**1.0 APPLICATION SUMMARY**

Applicant: Core Spaces  
 FLU Category: ICMU 35  
 Service Area: Urban  
 Site Acreage: 16  
 Community Plan Area: University  
 Overlay: None  
 Request: Modify Condition 5.2.

**Proposed Modification(s) Summary:**

**AGENCY REVIEW COMMENT SHEET**

CURRENT PD PLAN

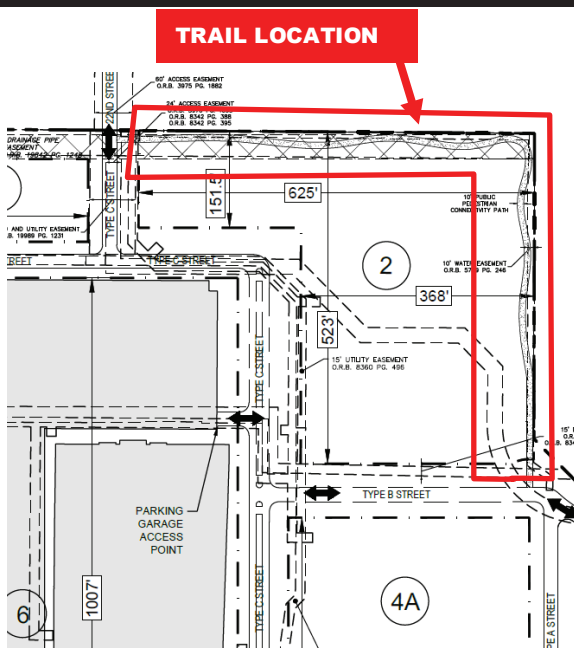
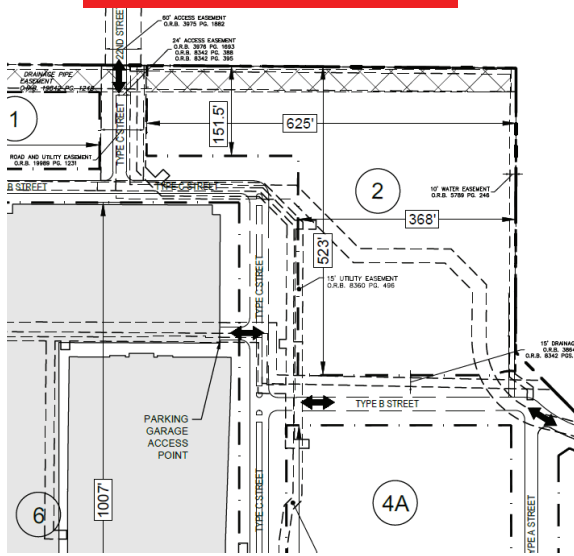
- The elimination of the pedestrian path along the eastern and north boundary.
- Changes to Condition 5.2 to reflect the same (including removing building facade design standards for elevations facing north and east).

ELIMINATION OF THE TRAIL

This new Minor Modification seeks to remove the multiuse trail (pedestrian and bike) from Block 2, along the east and north of the block. Therefore, the applicant proposes to eliminate the timing requirement to record the access easement and build the multi-use trail from Condition 5.2 (a and b). Since the trail is being removed from Block 2, the multi family building design standards for the facades facing the trail are also being removed from condition 5.2.

5.2 With the exception of Block 6, maximum block perimeters shall be 2,500 linear feet. With the exception of Block 2, blocks shall be bounded on all sides by streets. An alley may be provided between blocks to allow access to an existing parking structure or between a new building and an existing structure. ~~Additionally, the below conditions shall apply to Block 2 of the Development Plan:~~

- ~~a. An access easement area a minimum of 10 feet wide, for a multiuse trail (pedestrian and bike), shall be provided along the north and east of Block #2 as shown on the General Development Site Plan. The access easement shall be recorded no later than December 12, 2028.~~

- ~~c. Multifamily building facades facing the trail areas shall consist of windows and/or balconies at a minimum rate of 30% of the wall area. An additional 20 percent of the facades shall provide enhancements and expressions (features such as pilasters, columns, canopies/porticos, arcades or colonnades, with a projection or recess of at least two inches from the wall surface or murals). No more than 40 feet of horizontal distance of wall shall be provided without architectural expressions.~~

Proposed Configuration by PRS 24-0023

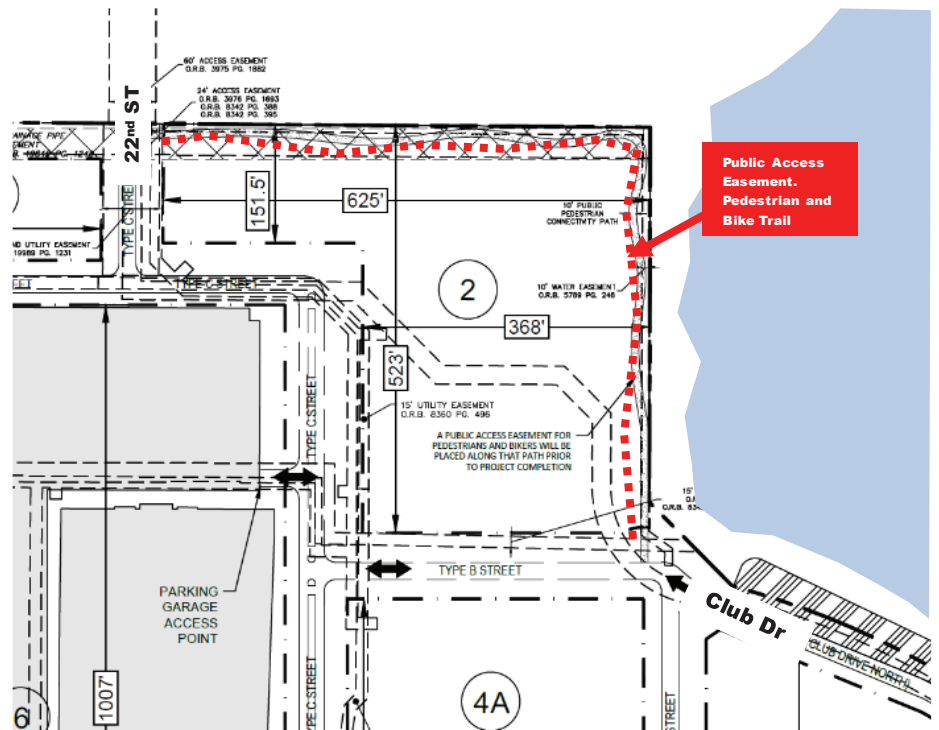
Two portions for Type B streets were removed on the north and east of the proposed new block. Since the new Block 2 lost streets frontages along the north and east, condition 5.2 was amended to also exempt the maximum block perimeters of 2,500 linear feet for new Block 2.

After staff evaluation of the PRS, the applicant made updates to the block design. A multiuse trail along the north and east of the new Block #2 was provided to allow pedestrian and bike access along the NE boundary of the project. The trail run adjacent to a pond located NE of the PD and will connect Club Drive from the southeast to 22<sup>nd</sup> St. to the northwest. Access by the public will be allowed by an access easement so that connectivity and integration contemplated by the overall project and the ICMU-35 FLU intent is maintained. The applicant proposed that the trail be a minimum of 10 feet wide.
